DEVIATION REQUEST AND DECISION FORM

Project Name :	Grandview Reserve
Schedule No.(s) :	
Legal Description :	<p>A TRACT OF LAND BEING PORTIONS OF THE SOUTH HALF OF SECTION 21, SOUTH HALF OF SECTION 22, NORTH HALF OF SECTION 28 AND SECTION 27, TOWNSHIP 12 SOUTH, RANGE 64 WEST OF THE SIXTH PRINCIPAL MERIDIAN, EL PASO COUNTY, COLORADO, BEING DESCRIBED AS FOLLOWS:</p> <p>BASIS OF BEARINGS: THE EAST LINE OF SECTION 21, BEING MONUMENTED AT THE SOUTHEAST CORNER BY A 3-1/4" ALUMINUM SURVEYOR'S CAP STAMPED "PS INC PLS 30087 1996", BEING APPROPRIATELY MARKED, AND BEING MONUMENTED AT THE NORTHEAST CORNER BY A 3-1/4" ALUMINUM SURVEYOR'S CAP STAMPED "PS INC PLS 30087 1996", BEING APPROPRIATELY MARKED, BEING ASSUMED TO BEAR NORTH 00 DEGREES 52 MINUTES 26 SECONDS WEST, A DISTANCE OF 5290.17 FEET.</p> <p>COMMENCING AT THE SOUTHEAST CORNER OF SAID SECTION 21; THENCE NORTH 00 DEGREES 52 MINUTES 26 SECONDS WEST ON THE EAST LINE OF SAID SECTION, A DISTANCE OF 2645.09 FEET TO THE NORTHEAST CORNER OF THE SOUTHEAST QUARTER OF SAID SECTION 21, SAID POINT BEING THE POINT OF BEGINNING; THENCE NORTH 89 DEGREES 41 MINUTES 03 SECONDS EAST ON THE NORTH LINE OF THE SOUTH HALF OF SAID SECTION 22, A DISTANCE OF 39

Figure 1- Proposed Cross Section for MST

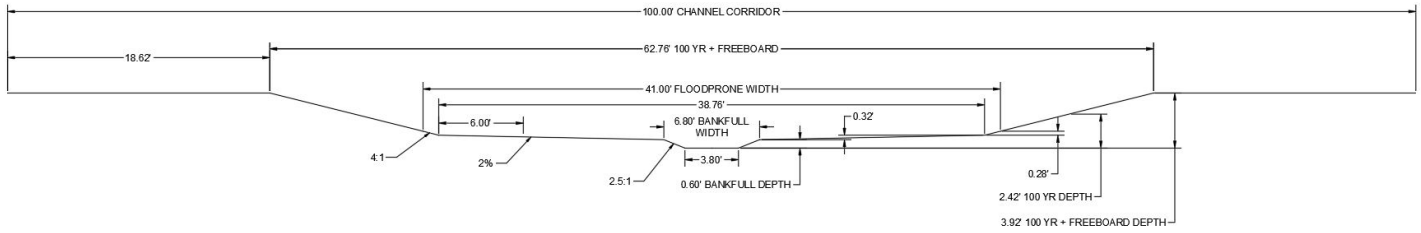
Section 10.5.3 Bottom Width: The majority of the channel B (Gieck Ranch Main Stem Tributary), is to see flows of less than 400 cfs and would not require a variance from section 10.5.3 as it would not be applicable. The final 700 feet of the channel are expected to see flow rates up to approximately 550 cfs during the 100-year flow events. It is requested that a channel less than 8 feet be permitted to facilitate a design that accounts for the wide range of expected flows through the stretch of channel being designed. The final design would take into account the higher flow rate and use a lower slope and **potential armoring** (either through native vegetation ~~selection or cobble~~) to prevent any negative degradation of the channel. **The final design will target a channel that is both stable and minimizes required maintenance. not armor**

What about baseflows upon development of the site?
